Morlais Project

Terrestrial Ecology Assessment Update

Document Reference: MMC353 MOR-RHDHV-DOC-0110 (4)

Updated assessments for terrestrial ecology (excluding chough) in response to comments made on the Environmental Statement by NRW and RSPB – version 04

LEGEND:
SPECIAL AREA OF CONSERVATION

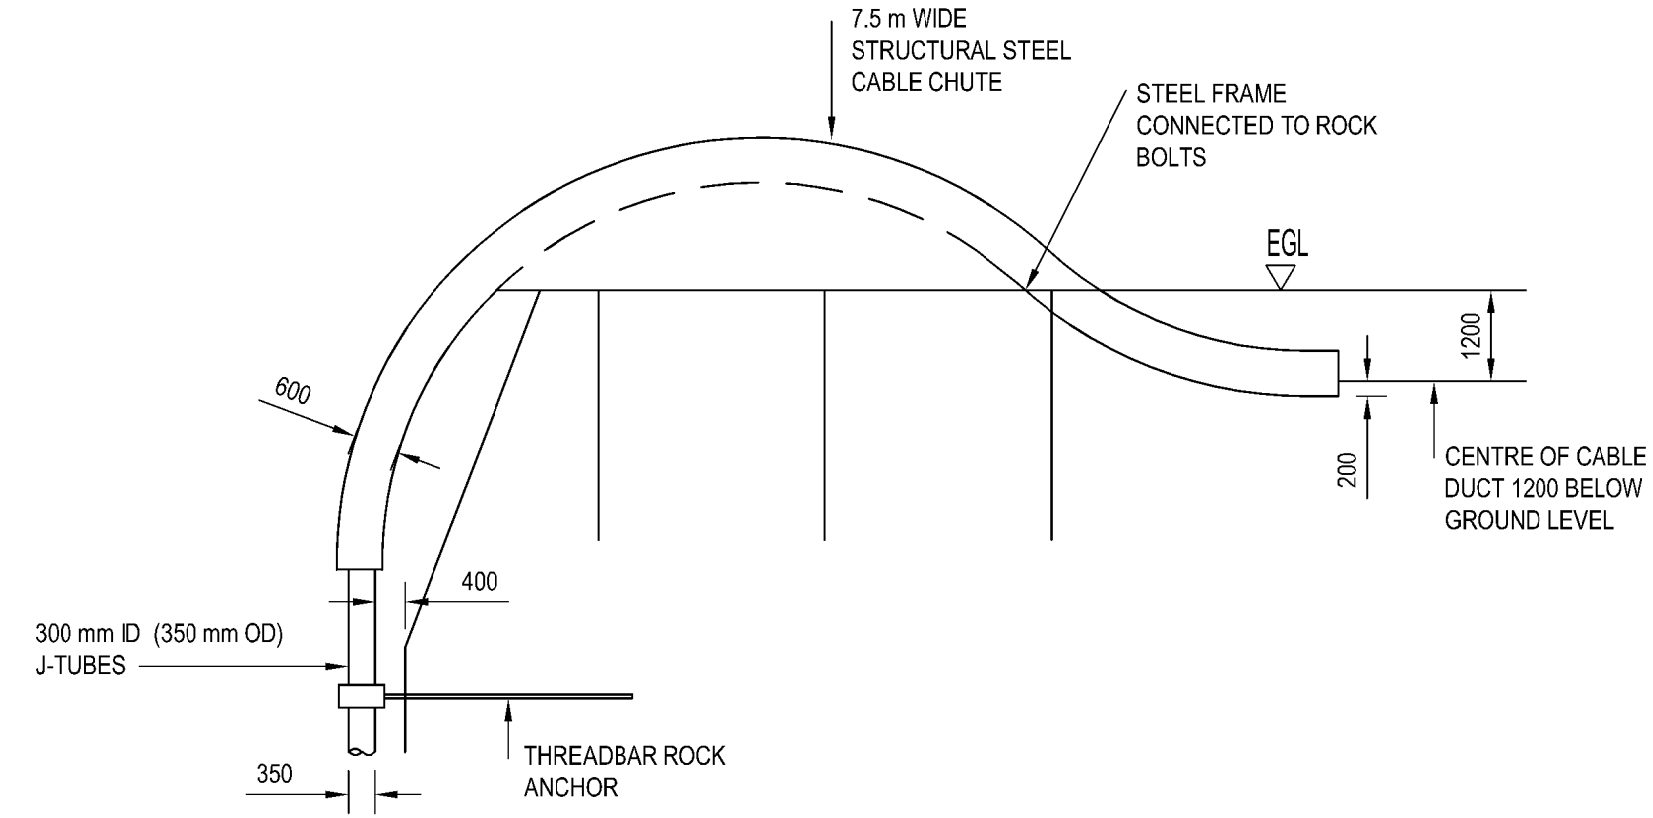
Comment Number	Comment Detail	Morlais Response
2	Drawing 2: Concrete apron at toe of cliff – up to Highest Astronomical Tide. There is a need to assess whether any qualifying SSSI features are present in this area: rockpools, caves and overhangs under boulders	These features do not appear on the citation for the SSSI https://naturalresources.wales/media/656113/SSSI_0963_Citation_EN001c75d.pdf
3	Drawing 2 shows the wrong SSSI boundary at the north-west end of the area where cables come ashore. It should follow mean low water but at c SH215815 the low water mark disappears and only the high water boundary is left.	Drawing 2 has been amended to better define the SAC boundary
4	The areas shown for stockpiles still seem quite small relative to the volumes of material to be stored, even allowing for opening trenches in short sections. Turf storage usually requires a lot of space.	For the construction phase of the project, a detailed Materials Management Plan will be developed by the contractor and submitted for acceptance by the client. All construction works will be programmed and undertaken to meet any planning and environmental constraints that are imposed on the works. It is however anticipated that the works will be phased to minimise environmental impact and disruption to local receptors. Construction of the works will be phased to suit available land take (e.g. stockpile and laydown areas) which will accommodate the temporary storage of turf as required. (See Section 5).
